RE: **Broadstone Highlands East Block
Grading and Drainage Plan
Engineer's Stamp Date: 2/7/18
Hydrology File: K15D034C**

Re: Broadstone Highlands East Block / Hydrology File K15D034C

Enclosed for your review and comment is a re-submittal of the Broadstone Highlands East Block Conceptual Grading & Drainage Plan. Please see the responses to your comments dated 02/01/18 below:

C1.00

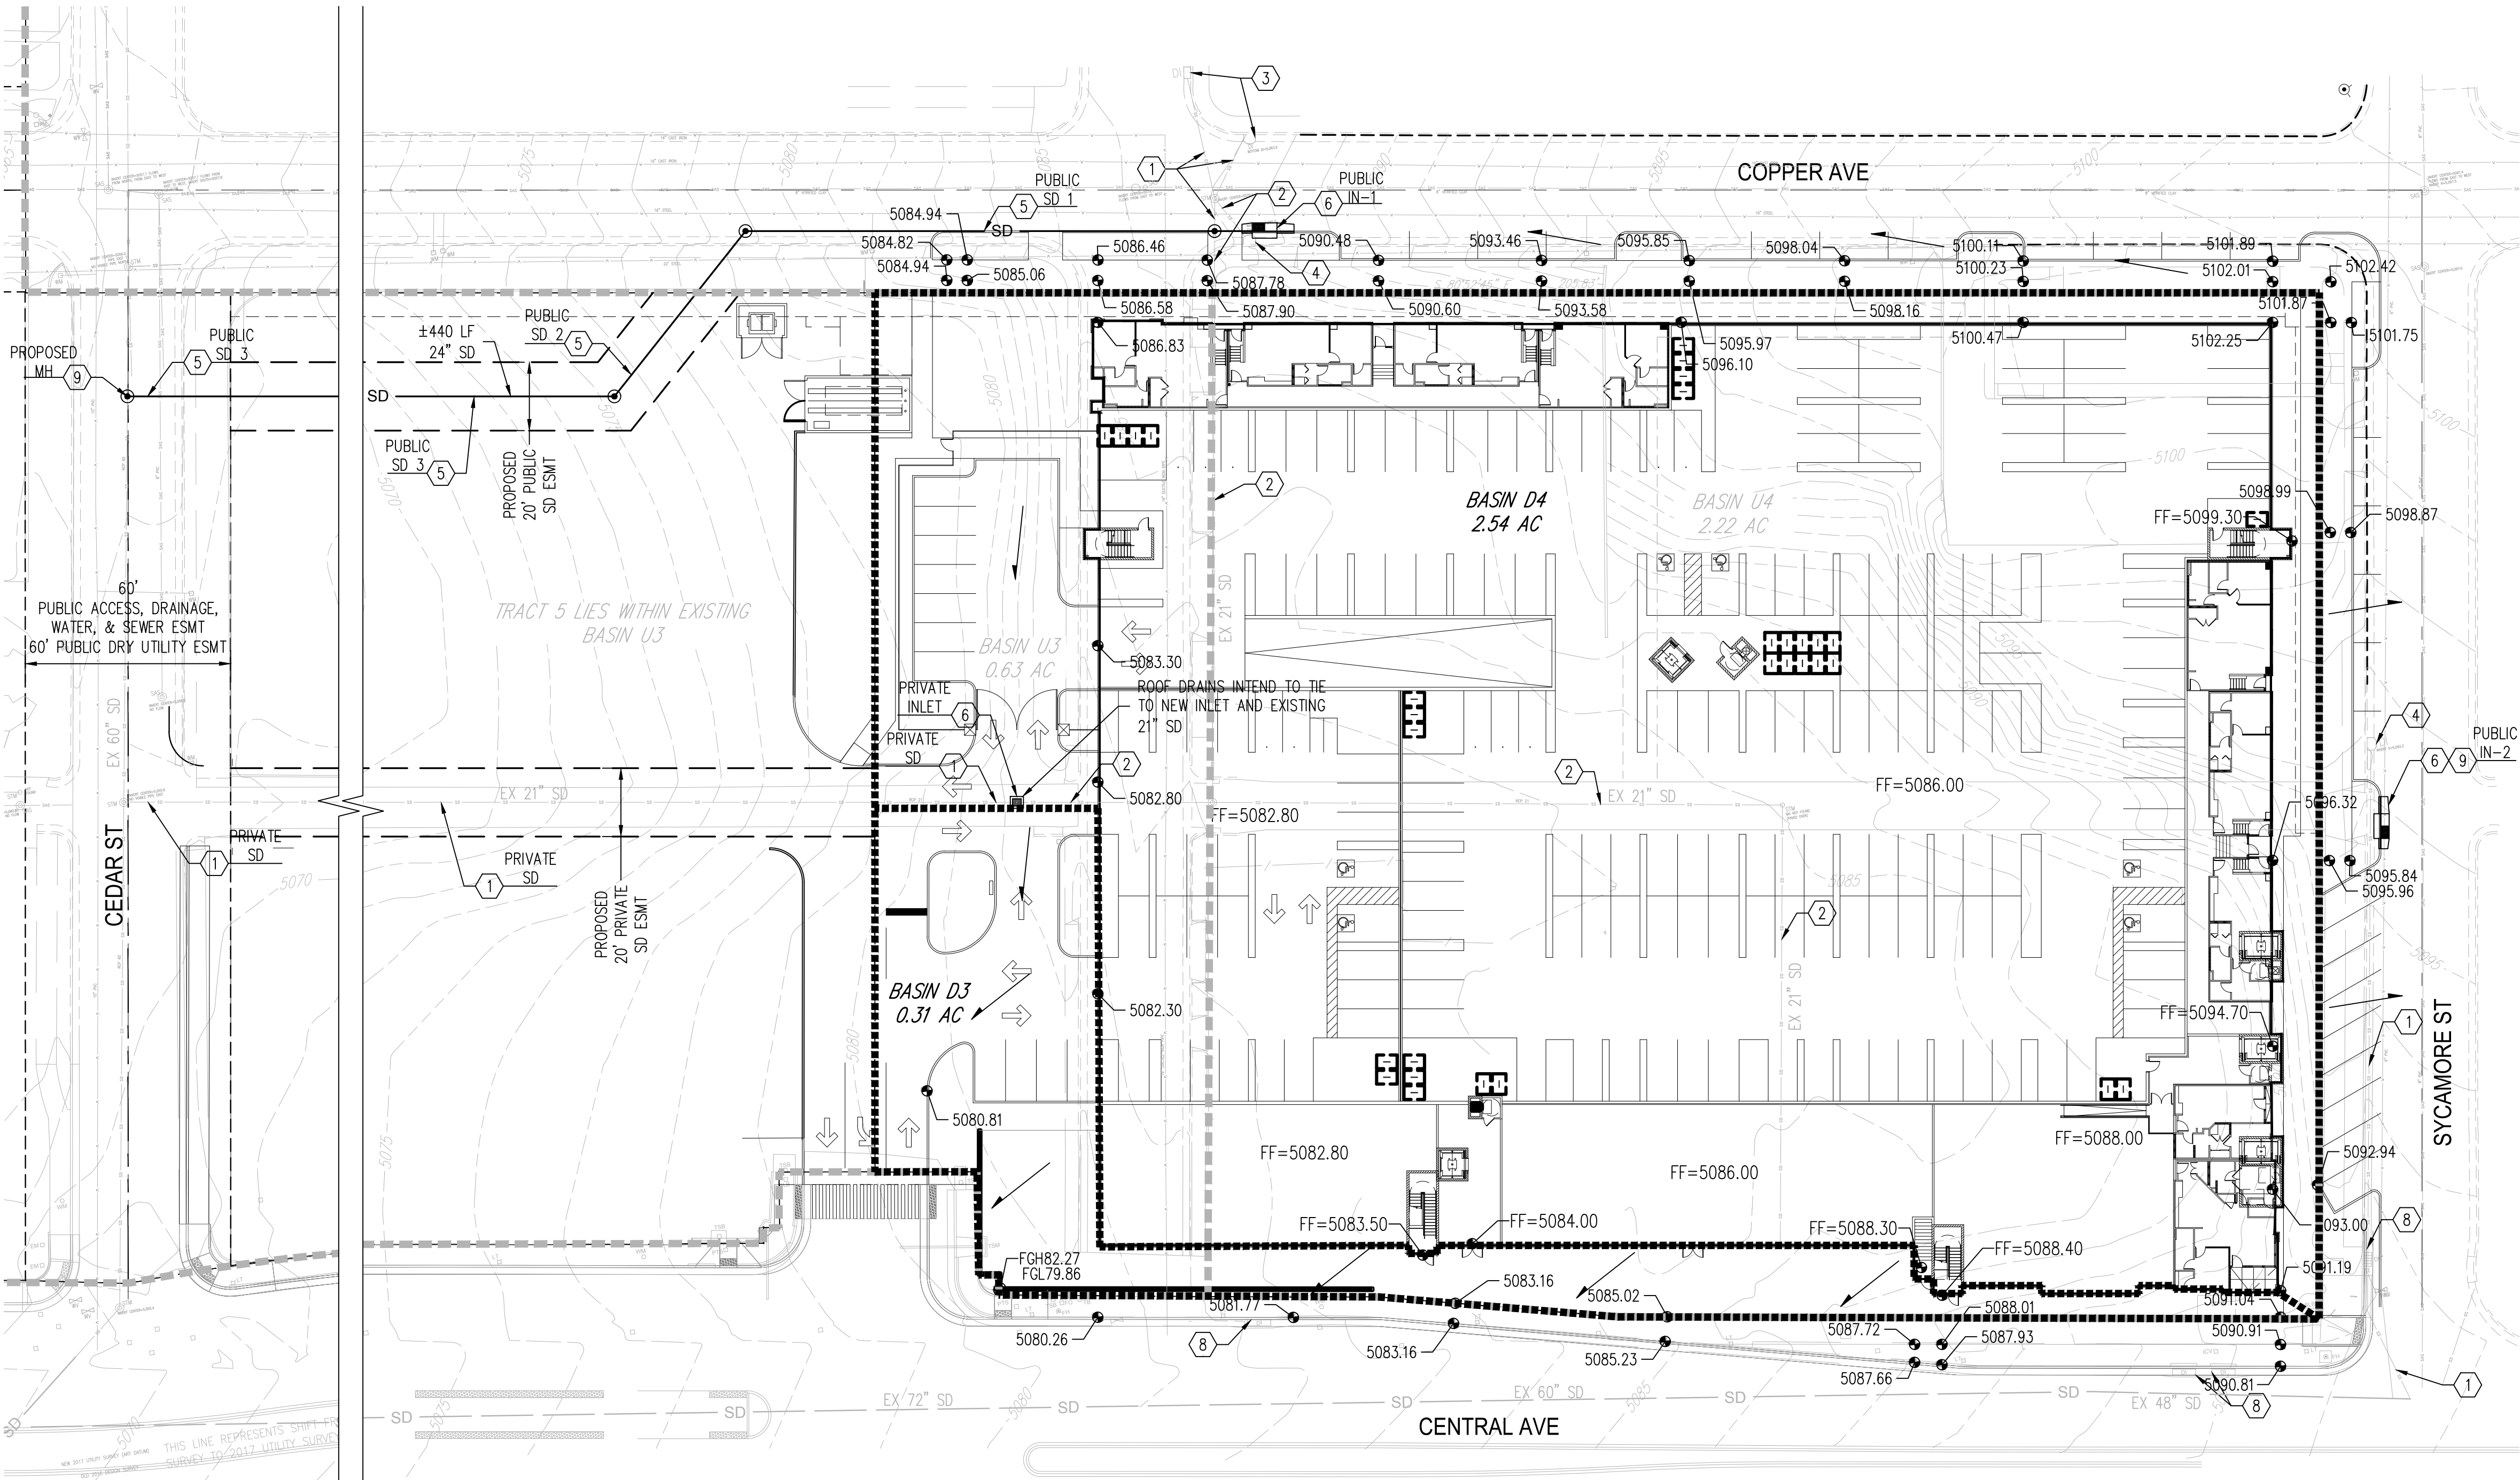
2. Clarify roof drainage and show on plans.
Response: At this time, the roof drains are conceptual but intend to drain to the existing 21" within Tract 5.

3. Label all Public vs. Private drainage improvements and ensure all improvements in the public ROW are on the infrastructure list.
Response: The public and private drainage infrastructure improvements have been labeled on the Conceptual Grading and Drainage Plan. The public infrastructure improvements have been included on the infrastructure list.

4. Clarify how the connections to existing storm drain will be made (keyed note 9). If there is no existing manhole to connect to, a new manhole will need to be built and included on the infrastructure list.

Response: Keyed note 9 has been expanded on regarding the type of connection to the existing storm drain. The infrastructure list includes all associated manholes and inlets within the footnote.

TRENCH PRISM AT DEEPEST INVERT

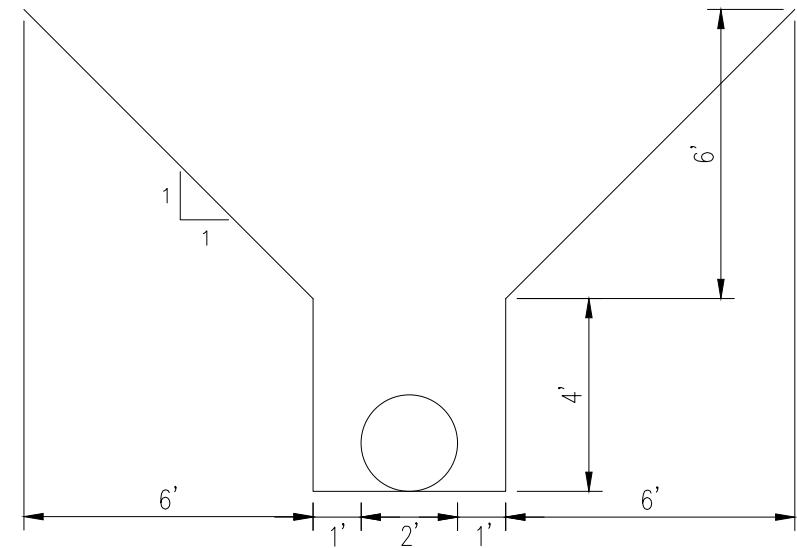
5. The new public storm drain easement (recorded) needs to be included on the infrastructure list. Provide a trenching prism at deepest point to evaluate the required width. The width will need to be at least 20' per DPM Ch.22, Section 6, Part C.

Response: The public storm drain easement will be included on the infrastructure list. A conceptual trenching prism has been provided on the "Supplemental Information" Exhibit to indicate that the minimum 20' wide easement will suffice for this storm drain at the deepest point.

**CONCEPTUAL GRADING & DRAINAGE SUBMITTAL
SUPPLEMENTAL INFORMATION**

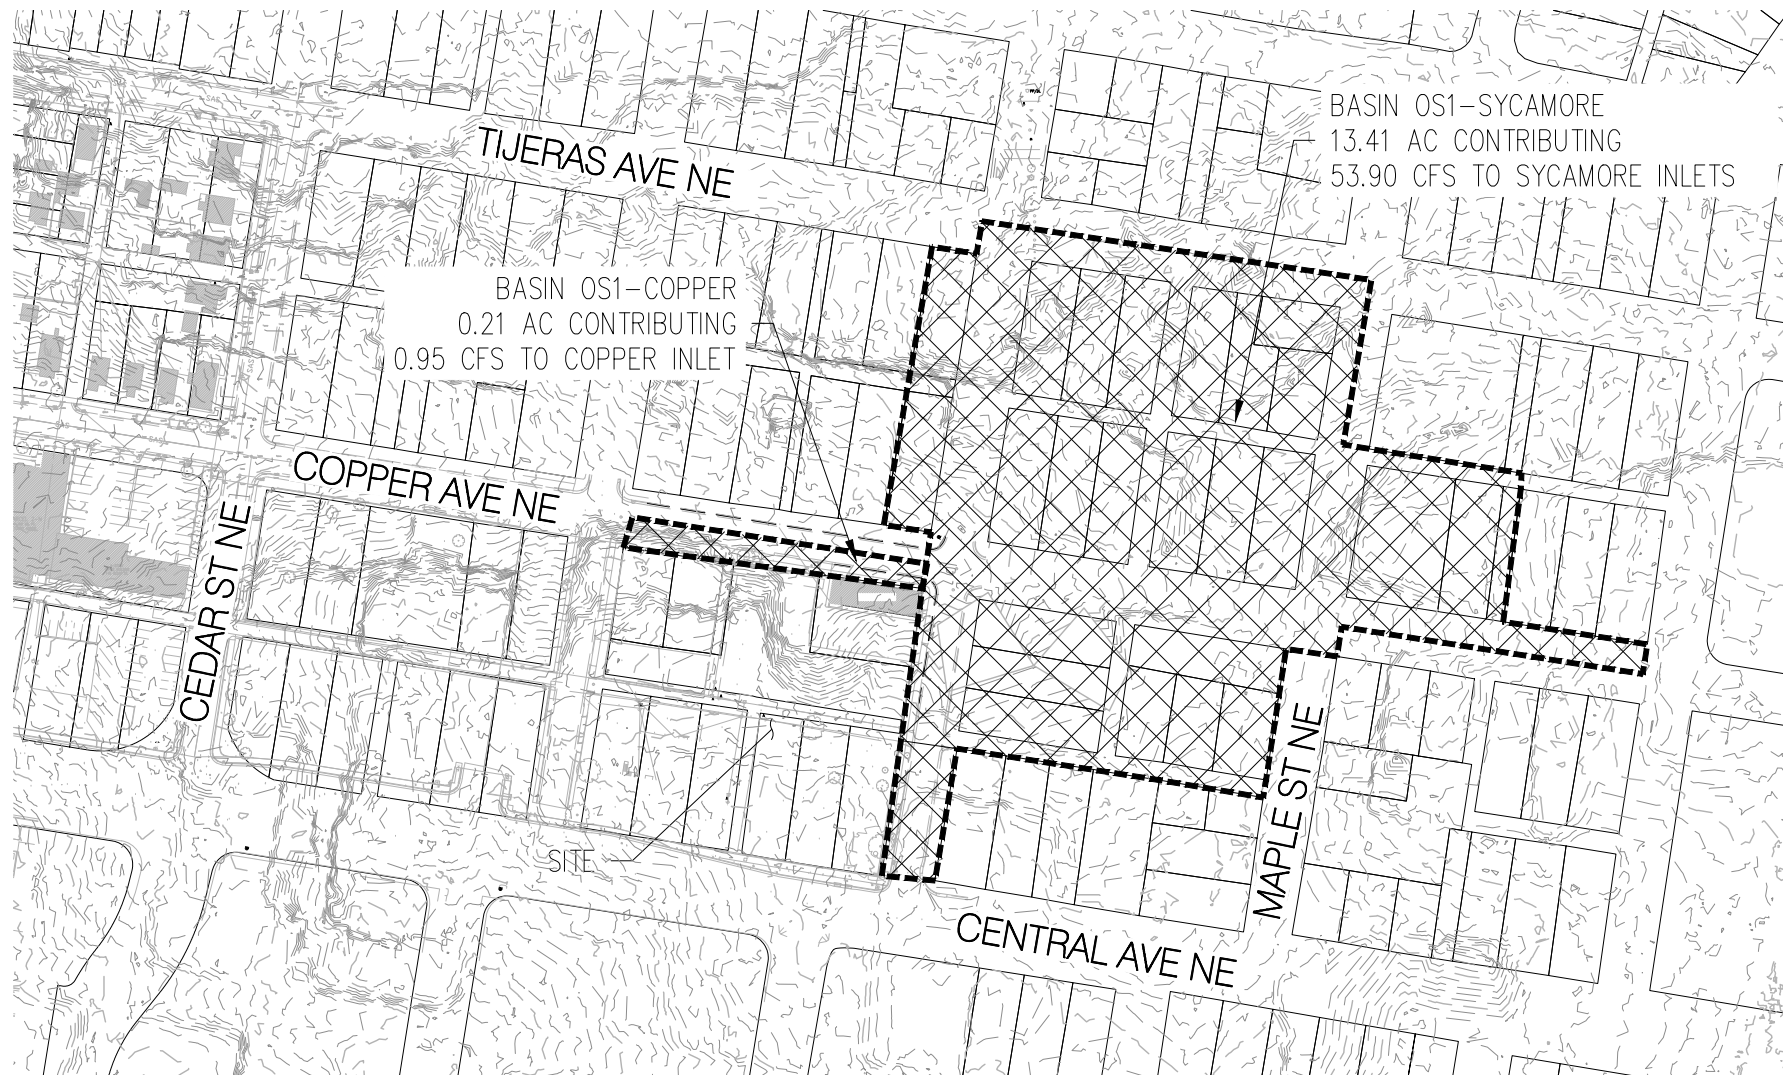
1. Include an off-site subbasin map, including topographic data.
Response: Please see the "Supplemental Information" Exhibit which indicates the offsite basins contributing to the inlets within Sycamore St and Copper Ave.
